NOTIFICATION

#0008

SUBJECT: Potential risk of trim tab motor disconnecting from elevator skin

MODELS AFFECTED: All Sling aircraft delivered prior to October 2020

Figure 1: Ensure all four attaching screws are present

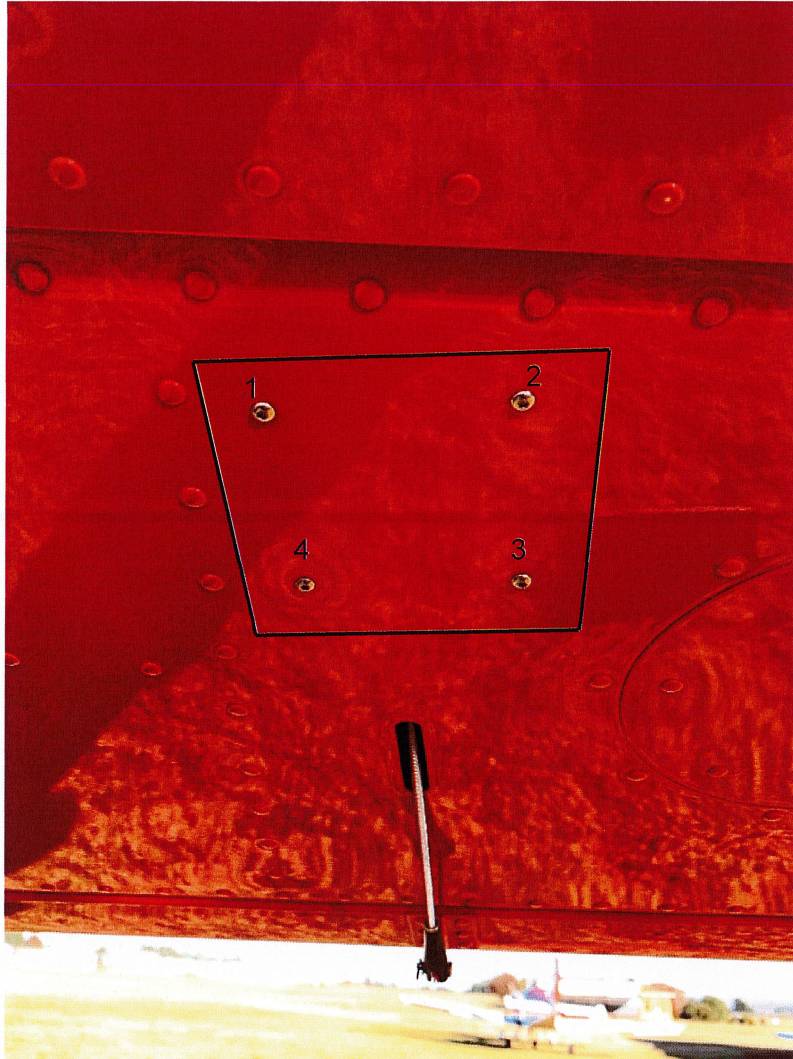
- a) The trim tab motor is secured to the elevator skin with four M3x10mm button head screws. Check that all four screws are present as shown in Figure 1.

- b) Missing screws must be re-installed with Loctite 222.
- c) In the unlikely event that missing screws result from rivnut failure (such as the rivnuts(s) breaking off from the trim motor flange), rivnuts must be replaced with 8-32 single lug anchor nuts, provided the trim motor flange is absent of damage that would prevent re-use.

- e) For aircraft produced after October 2020, the M3 rivnuts and M3x10mm button head screws have been superseded by 8-32 single lug anchor nuts and 8-32 x 1/2" stainless steel machine screws, respectively, to reduce the risk of trim motor disconnection.
